Access Compliance Report

Public Rights-of-Way

Intersection ID: 13854	Main Street: E_PARK_AV	Cross Street: SOUTH_BV	Location: NW
ADA ID: 3F084626E588	Ramp Type: BlendTrans1	Initial Pass/Fail: Pass	Overall Compliance: No
Severity Score: 5.25			
Codes/Mitigation Info/Possible Solution		Field Measurements/Component Compliance

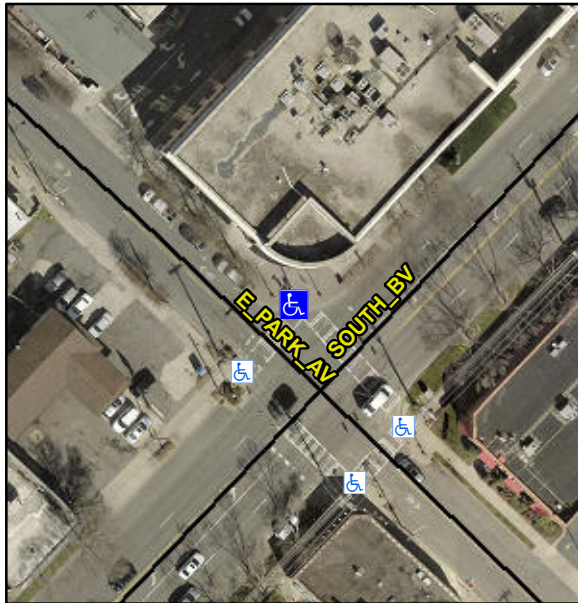
Not Found, R304.5.3, R207.1, R304.5.4

Compliance	Description	Data	Compliance	Description	Data
N/A	Ramp Length (in)	24.0	Yes	BlendTrans Slope (%)	1.3
Yes	Ramp Width (in)	48.0	No	BlendTrans XSlope (%)	2.1
N/A	Flare Type LT	Sloped	N/A	Flare Type RT	Sloped
Yes	Flare Slope LT (%)	4.6	Yes	Flare Slope RT (%)	3.5
N/A	Flare Traversable LT?	Yes	N/A	Flare Traversable RT?	Yes
Yes	Landing Length (in)	48.0	Yes	DWS Provided?	Yes
Yes	Landing Width (in)	48.0	Yes	DWS Contrast?	Yes
Yes	Landing Slope (%)	1.0	Yes	DWS Length (in)	24.0
Yes	Landing X Slope (%)	1.3	Yes	DWS Full Width?	Yes
N/A	Landing Curb? (Y/N)	No	Yes	DWS Offset (in)	1.0
N/A	Shared Landing?	No			
Yes	Gutter Ponding?	No	No	Gutter Slope (%)	6.3
Yes	Gutter Lip Ht (in)	0.0	Yes	Gutter X Slope (%)	1.6
N/A	Painted X Walk1?	Yes	N/A	Painted X Walk2?	Yes
	X Walk 1 Direction	To SW		X Walk 2 Direction	To SE
	X Walk 1 Width (in)	111.0		X Walk 2 Width (in)	102.0
	X Walk 1 Slope (%)	4.0		X Walk 2 Slope (%)	5.4
	X Walk 1 X Slope (%)	4.0		X Walk 2 X Slope (%)	0.7

Yes	Ramp inside XWalk1?	Yes	No	Ramp inside XWalk2?	No
	Road Slope (%)	1.6		Clear Space?	Yes
	Road X Slope (%)	5.5	No	Clear Space to XWalk (in)	30.0
Yes	Any Obstructions?	No	Yes	Storm Grate/Utility Hazard?	No
	Obstruction Type			Storm Grate/Utility Type	
		N/A			N/A
			Yes	Surface Condition? (G/P)	Good
			No	Curb Slope (%)	5.6

Remove & Replace Curb Ramp With Two New Directional Ramps or Equivalent. Restripe Crosswalk(s) To Provide Clear space. Remove & Replace Gutter.
